4328 Brooklyn Ave NE

Recommendation Meeting

SDCI: 3036008-LU

February 28, 2022

Landscape: Pocket Park (site plan)

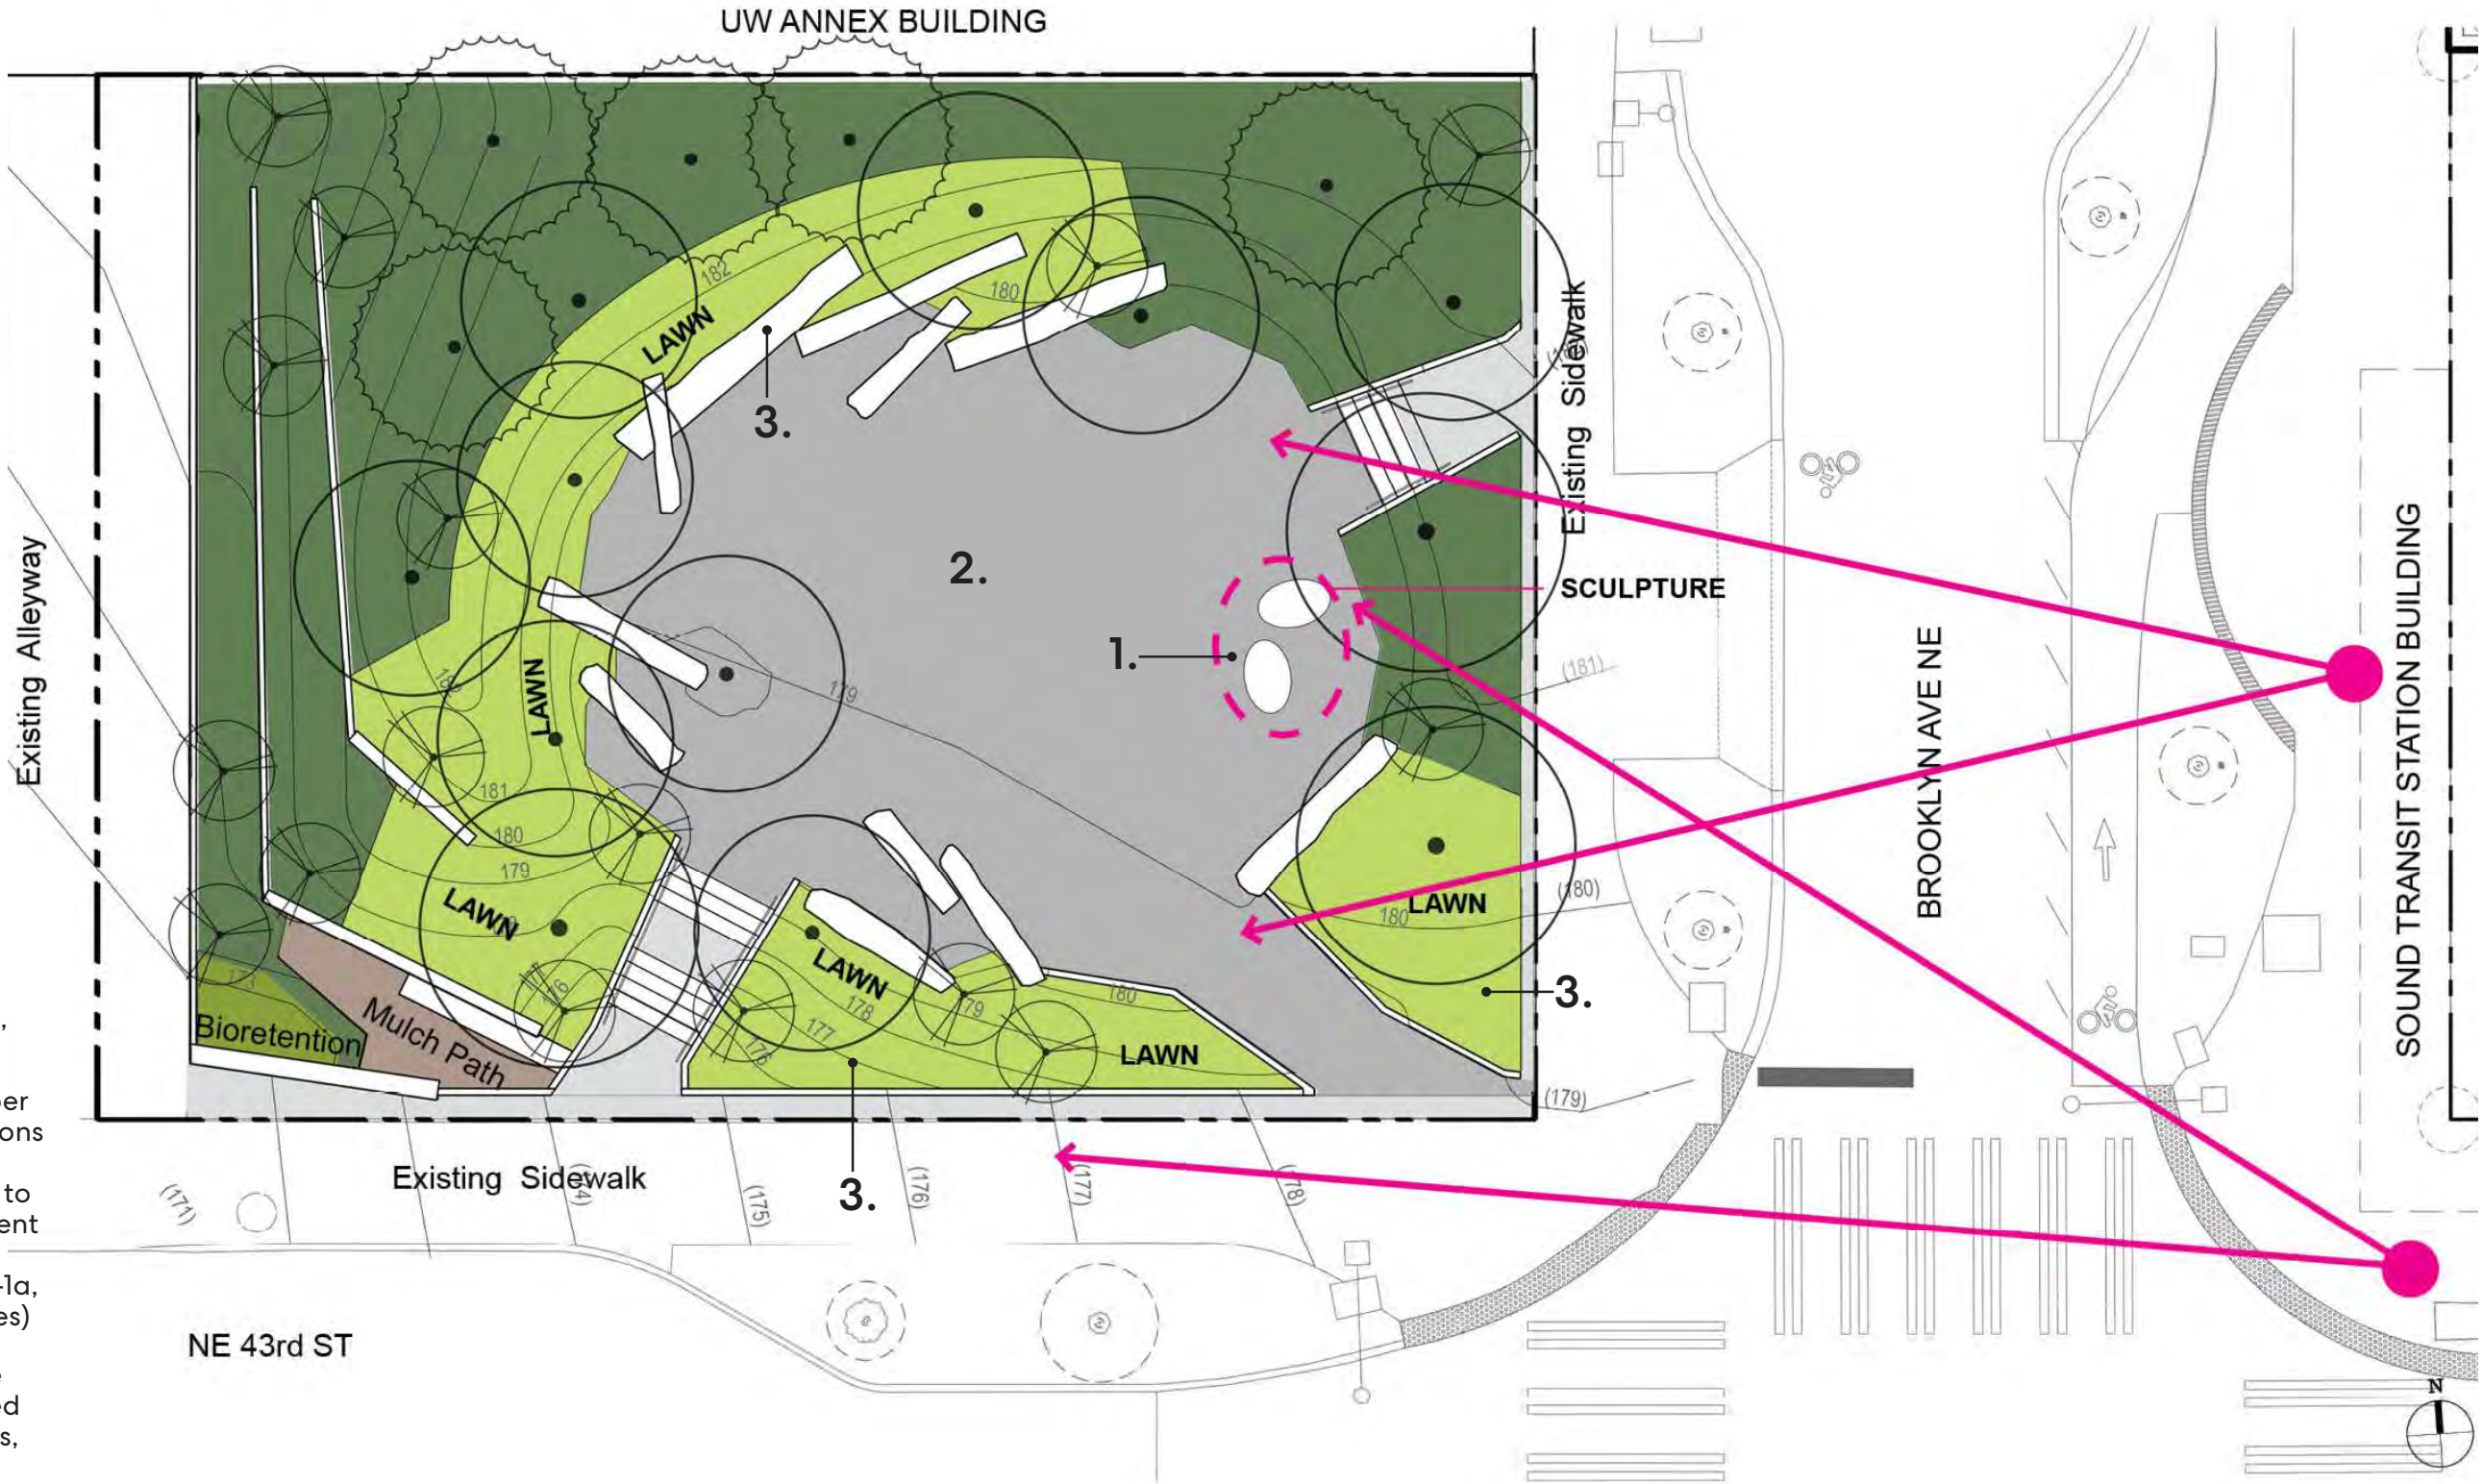
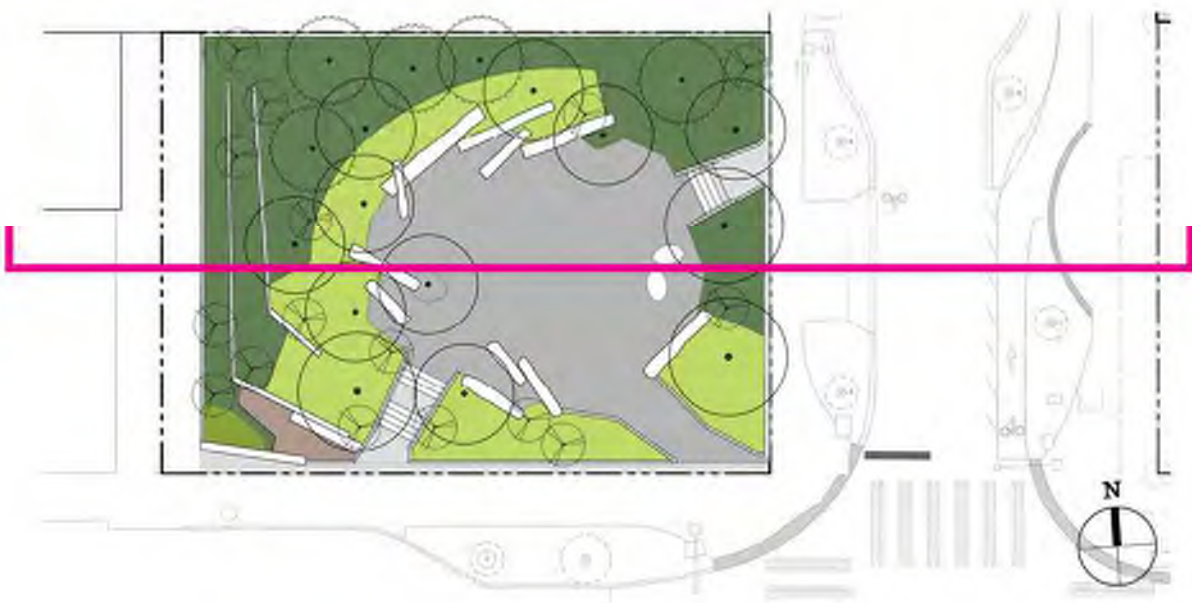
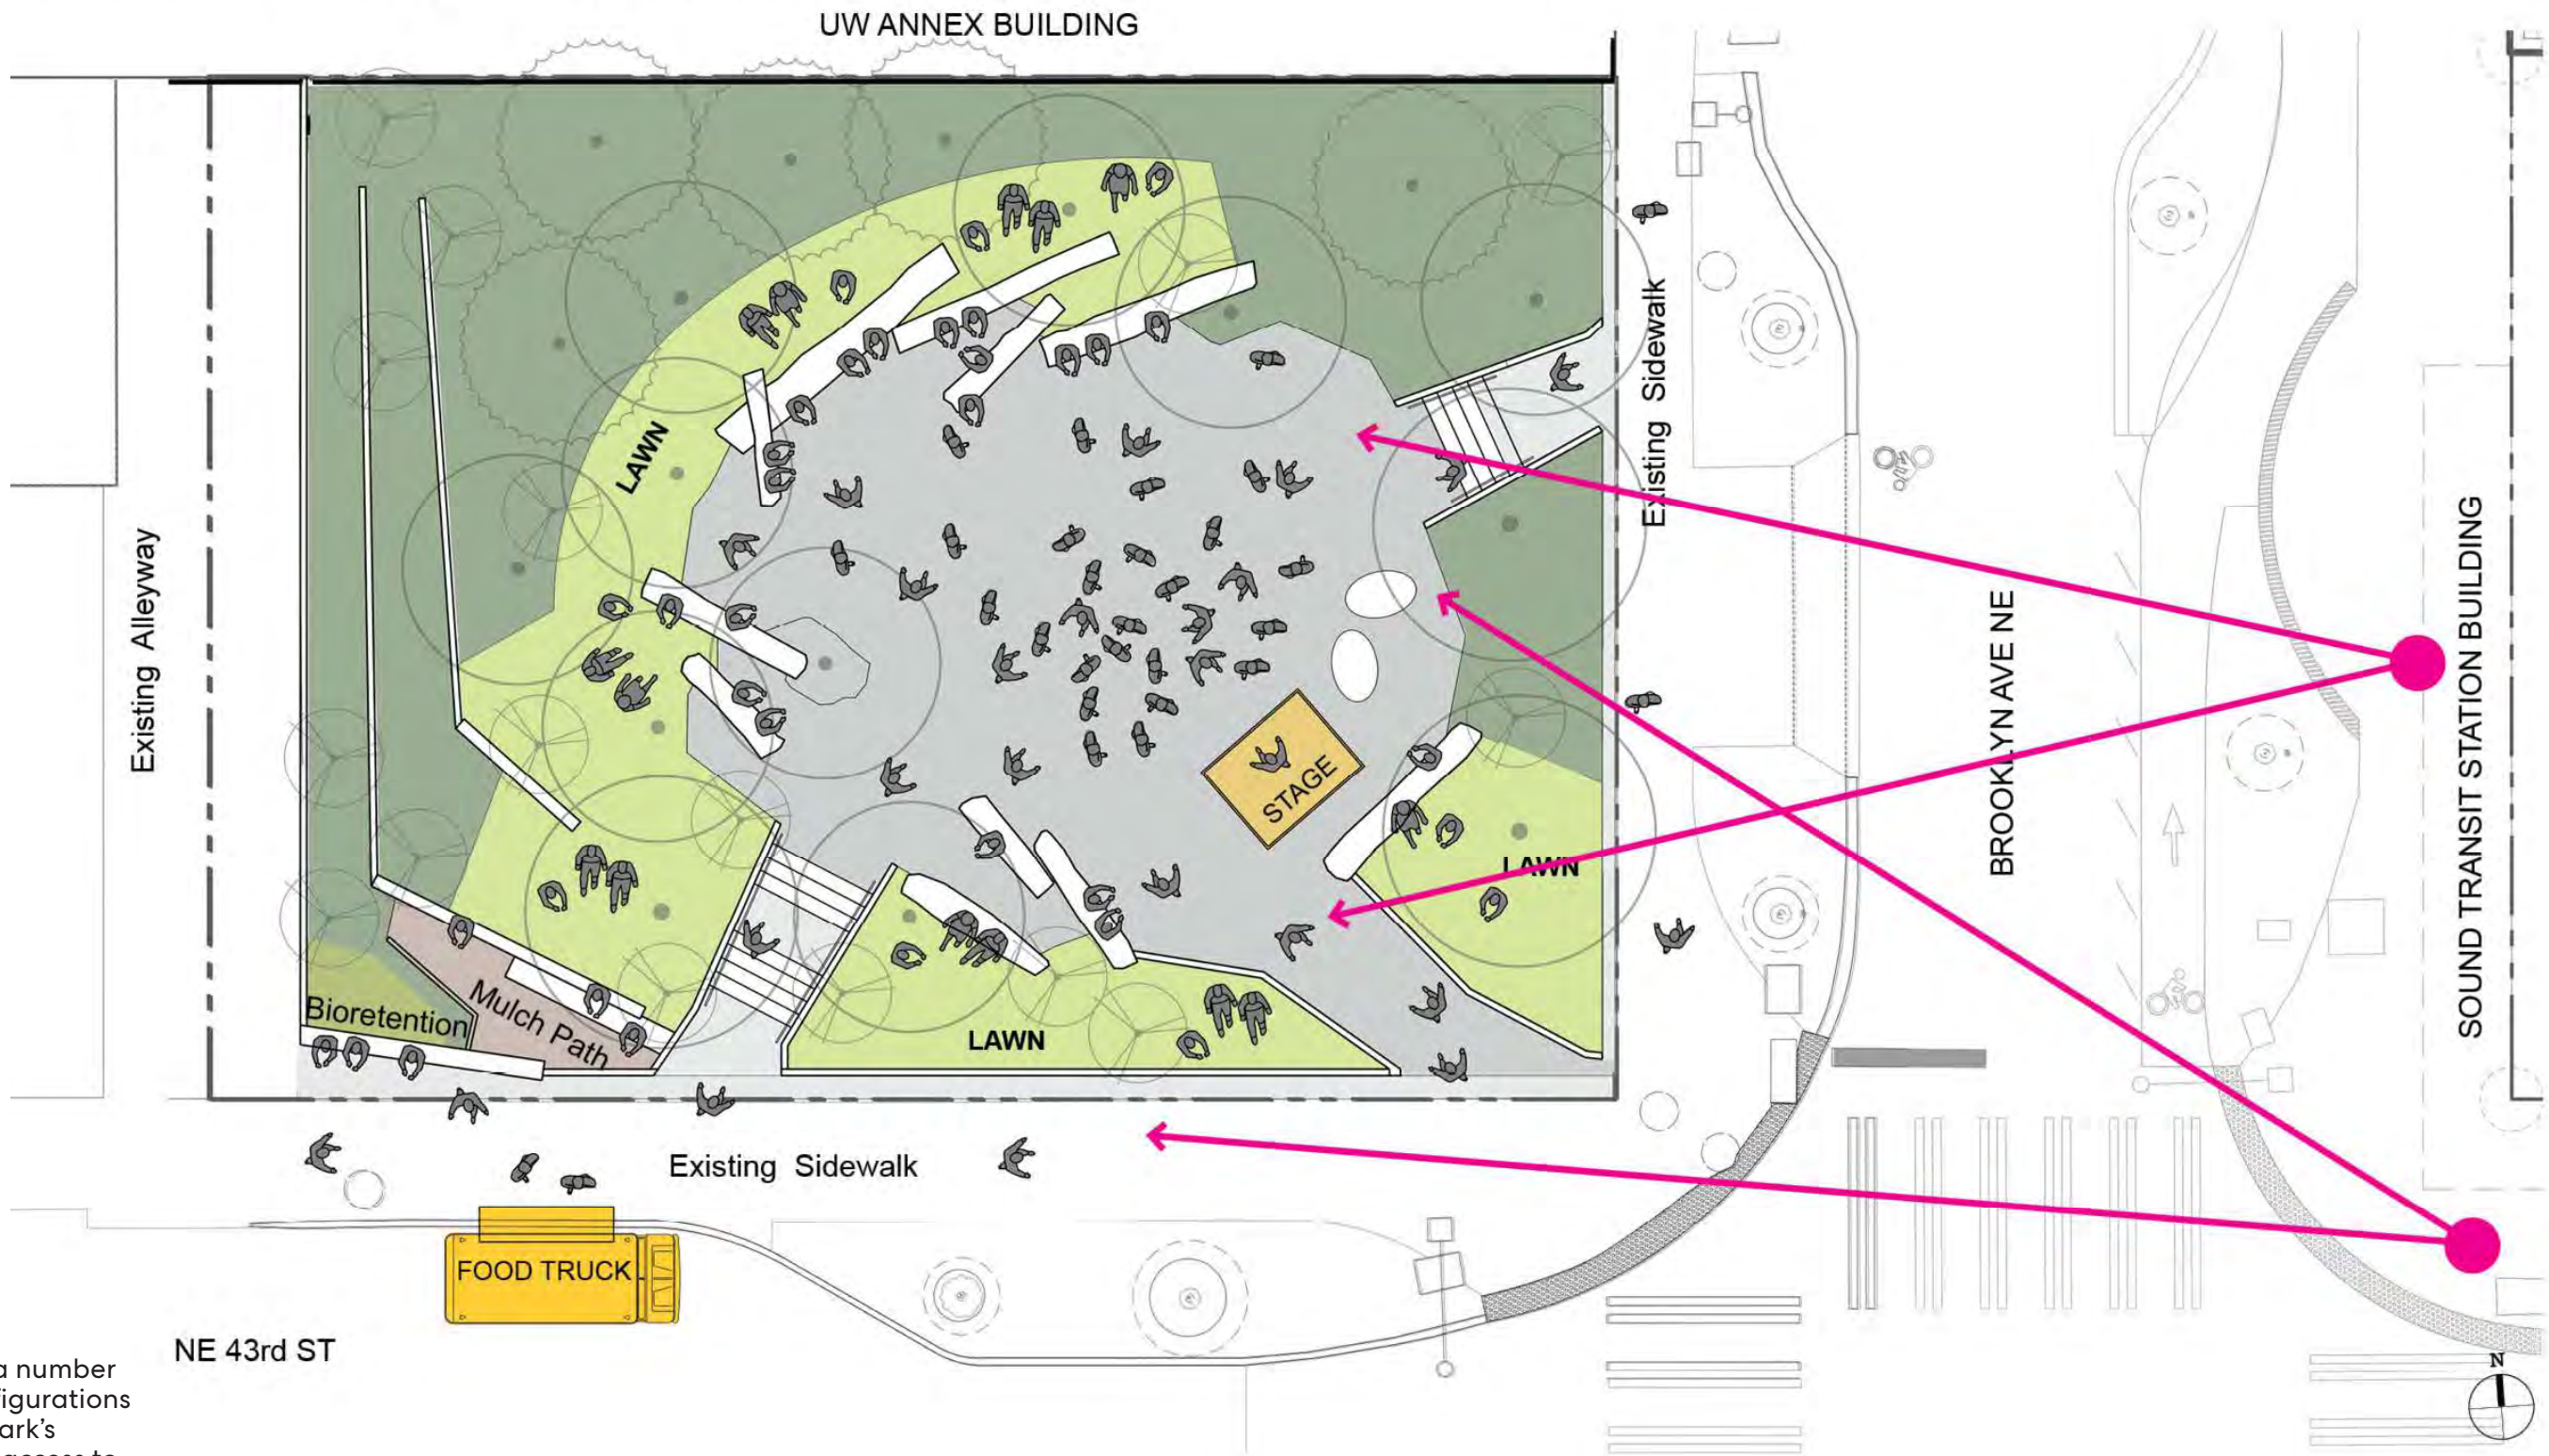
- 2a) Being located across from a busy transit station, the pocket park should have some sort of highlight or feature, “something cool” that will draw people into the park and activate it; optimize the open space and circulation so the park does not feel like a dead-end and is across from a busy transit station
- 2b) Consider park’s potential uses and users to provide maximal benefit and the best urban design

1. A public art installation is being considered along the park’s east edge, directly across from the transit station entrance, and will serve as a visual attraction for pedestrians and neighborhood residents alike (CS2-2a, CS3-1, DC1-A.2, DC3-C.2, DC3-1a)
2. The design team studied a number of potential program configurations and have optimized the park’s open space and points of access to accommodate a variety of different uses and users (DC1-A.2, DC3-B.1, DC3-C.2, DC3-1a, DC3-3b)(see section.06 for studies)
3. The edges of the pocket park are thoughtfully designed with sloped lawns, shaded and planted areas, and stepped seating creating opportunities for individuals and groups to gather for a variety of different types of community interaction (DC1-A.2, DC3-B.1, DC3-C.2, DC3-1a, DC3-3b)

2a)
The design team studied a number of potential program configurations and have optimized the park's open space and points of access to accommodate a variety of different uses and users (DC1-A.2, DC3-B.1, DC3-C.2, DC3-1a, DC3-3b) (see section.06 for studies)
